Winter Dress Limited (Extension)

5 December 2023

1. Observations

Observation-1: Absence of design report (Utility Building).

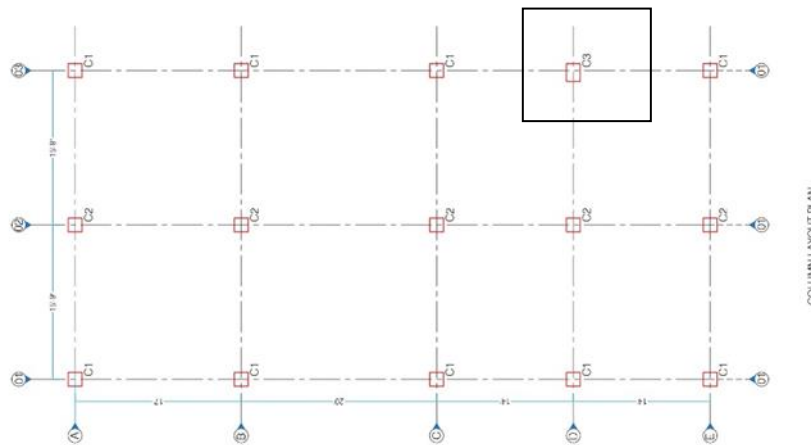
Utility Building	Long columns
Description: The design report of the Utility building was not prepared for the Utility Building. Long column adequacy is required to check in the design review. The building engineer is required to prepare a design report following BNBC (part-6, section 1.9.1)

Observation	Action Plan	Timeline
Absence of design report. (Utility Building).	The building engineer is required to prepare a design report considering BNBC (part-6, Section-1.9.1)	within 6 weeks
	The building engineer is required to review the design of the long columns.	within 6 weeks
	Carry out suggested remedial works if required.	within 6 months
Reinforcement and size confirmation of C3 column (Utility Building).	The building engineer is required to prepare accurate the as-built and confirm the size and rebar of the C3 column.	within 6 weeks
Absence of design report. (Fire Control Building).	The building engineer is required to prepare a design report considering BNBC (part-6, Section-1.9.1)	within 6 weeks
	Carry out suggested remedial works if required.	within 6 months
Mismatch in as-built drawing. (Fire Control Building)	The building engineer is required to prepare accurate as-built drawings.	within 6 weeks
